CITY OF FORT LAUDERDALE

CASE COMMENT REPORT

CASE NO. UDP-S25031

CASE	UDP-S25031
PROJECT NAME	2800 East Oakland Park Boulevard Mixed-Use Project
APPLICATION TYPE	Site Plan Level III
APPROVAL LEVEL	Planning and Zoning Board, City Commission Request for Review
REQUEST	Conditional Use for Mixed-Use Development with Allocation of 94 Flex Units and 4,900 Square Feet of Commercial Use
APPLICANT	2810 E. Oakland, LLC.
AGENT	Tracy H. Lautenschlager, Greenberg Traurig
PROPERTY ADDRESS	2800 E. Oakland Park Boulevard
ABBREVIATED LEGAL DESCRIPTION	Oakland Ocean Mile 28-45 B Lot 1 less N 50 for Street
ZONING DISTRICT	Community Business (CB) District
LAND USE	Commercial
COMMISSION DISTRICT	1 – John Herbst
NEIGHBORHOOD ASSOCIATION	Coral Ridge Association
SUBMITTED	August 22, 2025
COMPLETENESS ISSUED	August 27, 2025
STATE STATUTE 166.033 EXPIRATION	February 23, 2026 (180 Days)
CASE PLANNER	Michael Ferrera, Urban Planner II

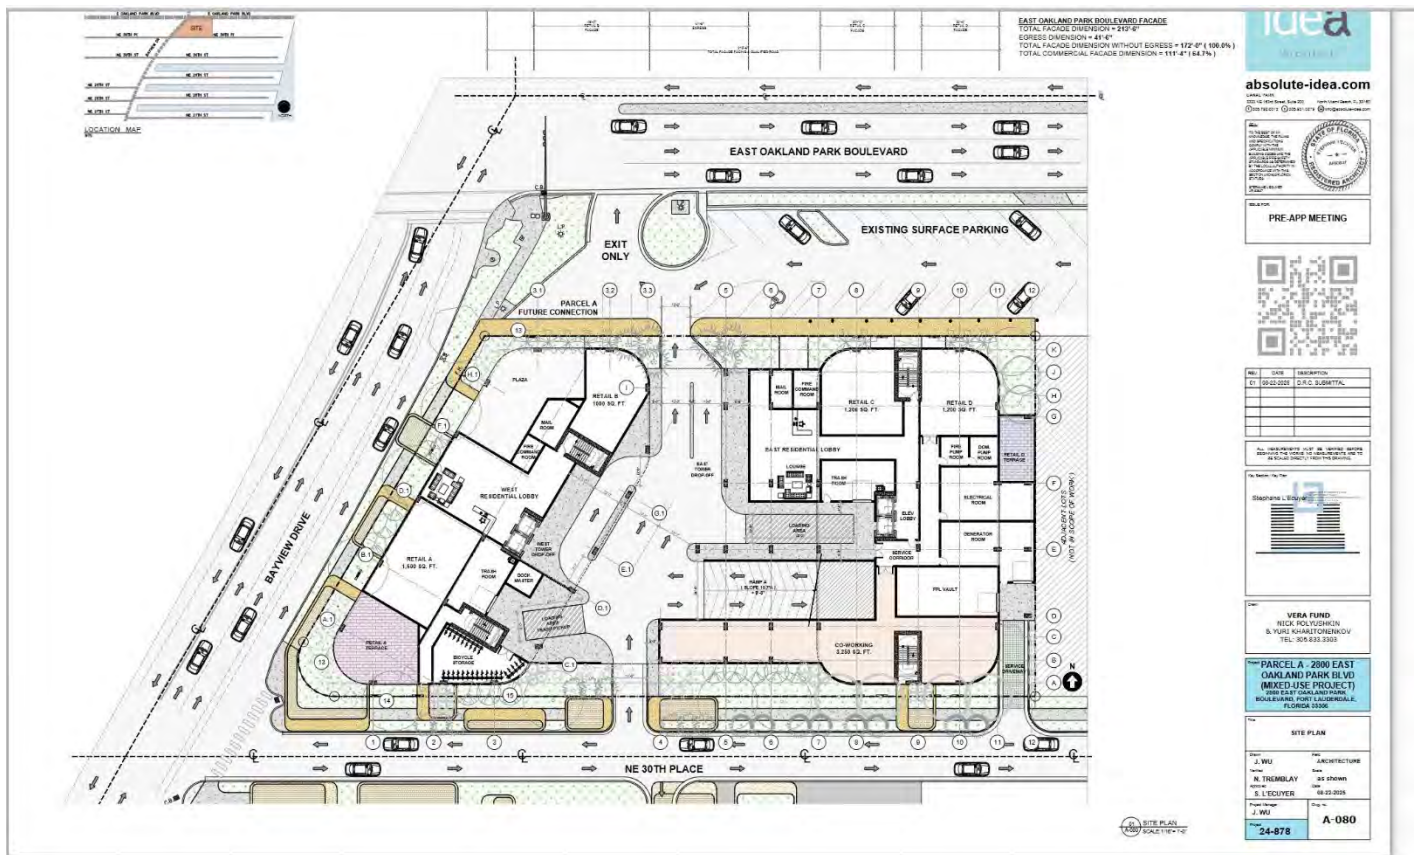
1. Flood Zone in effect at time of submittal), "AE" (BFE 6', + 1.4 = 7.4 ft. NAVD)and a small section near front of lot is in a (BFE 7')
2. The plans submitted do not show any Finish floor elevations.
3. Provide the following FFE elevations on (sheet A-501 North Elevation),(Sheet A-502 South Elevation), (Sheet A-503 West Elevation), and (East Elevation Sheet A-504).
4. (Sheet A-502 shows a connections on level 2 to connect both buiding.
5. Sheet A-080 shows west tower with retail areas and east tower. (see attached)

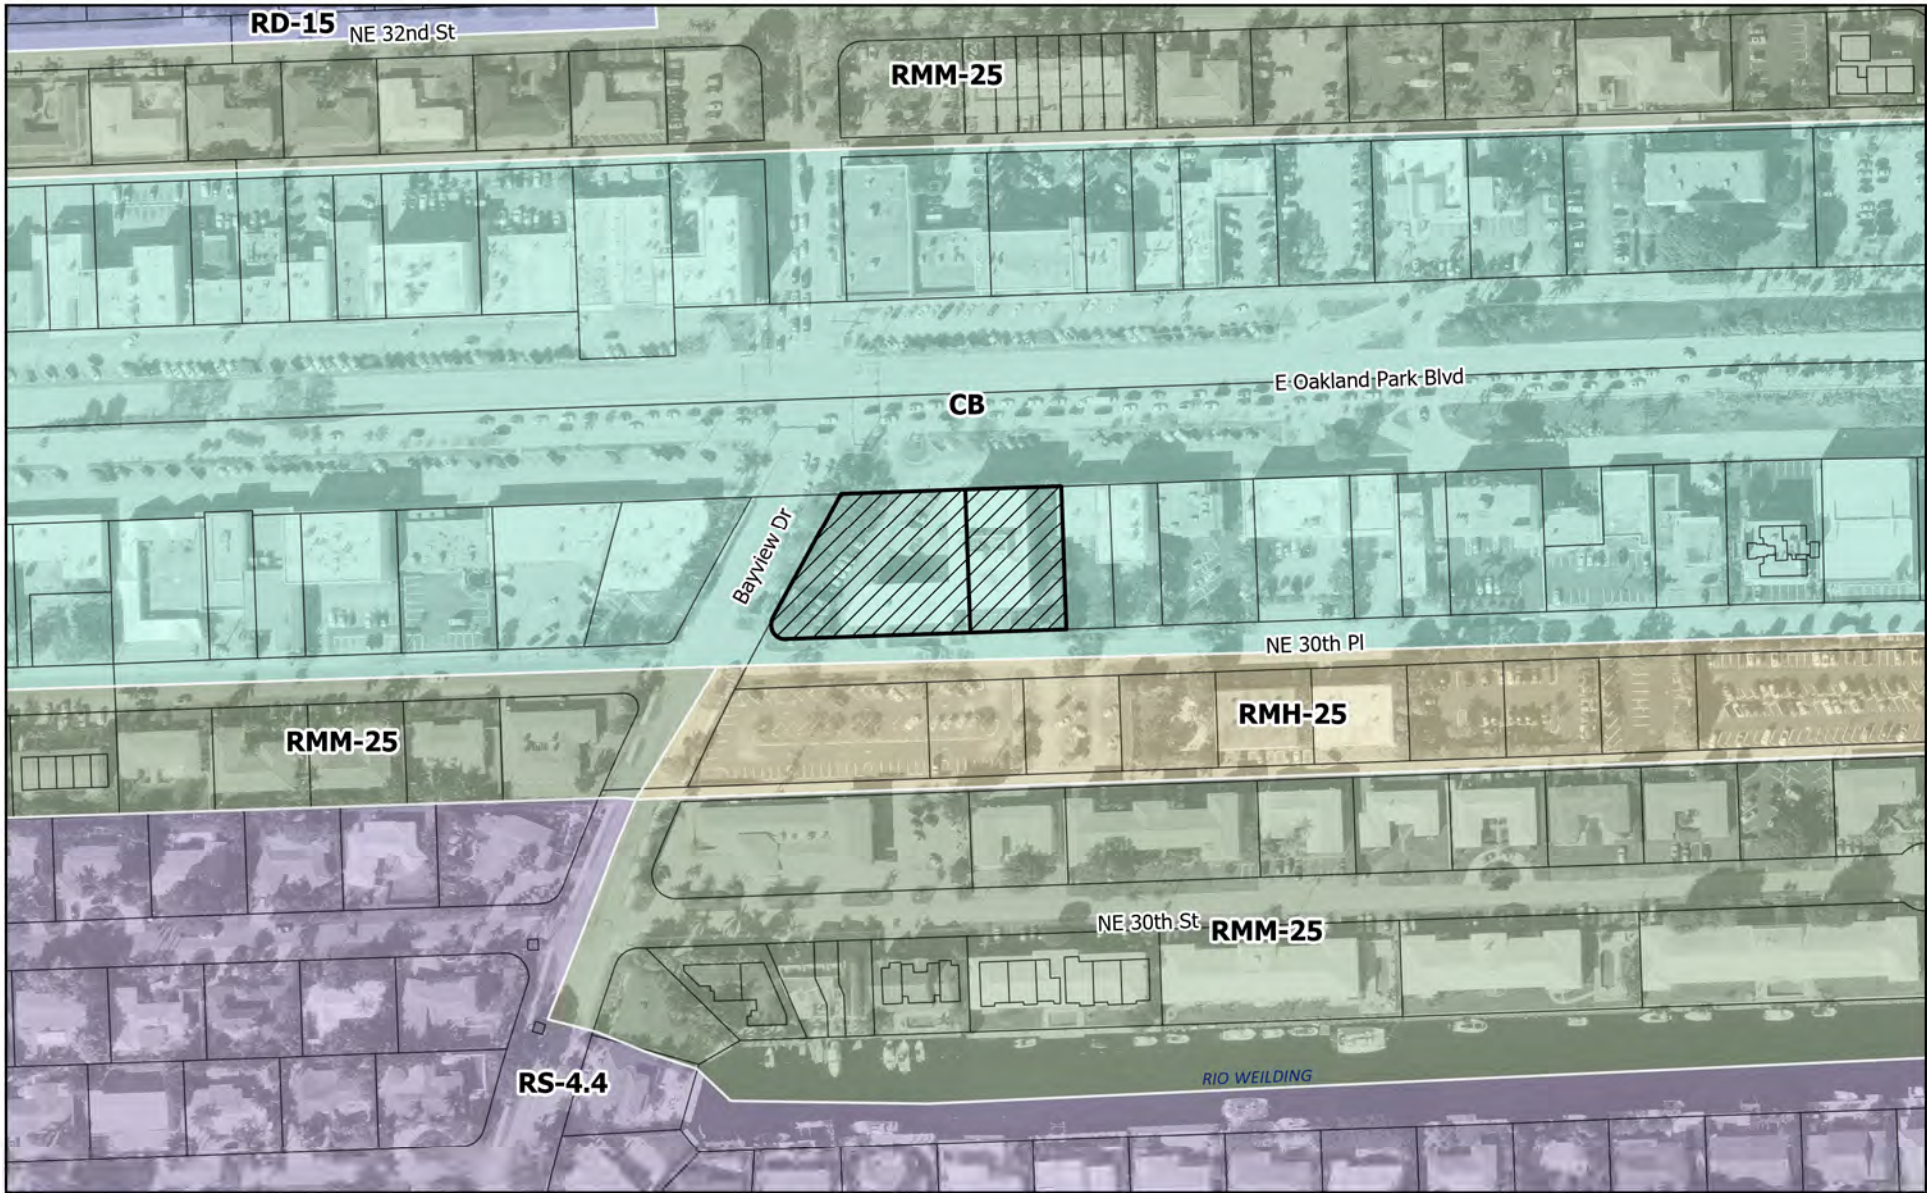
- d. Provide a minimum 7 foot clear and unobstructed sidewalk throughout the entirety of the project.
 - e. Staff recommends the applicant provide a mood board and renderings depicting how the project is meeting the open space and plaza requirements as commented hererin. See example image below.
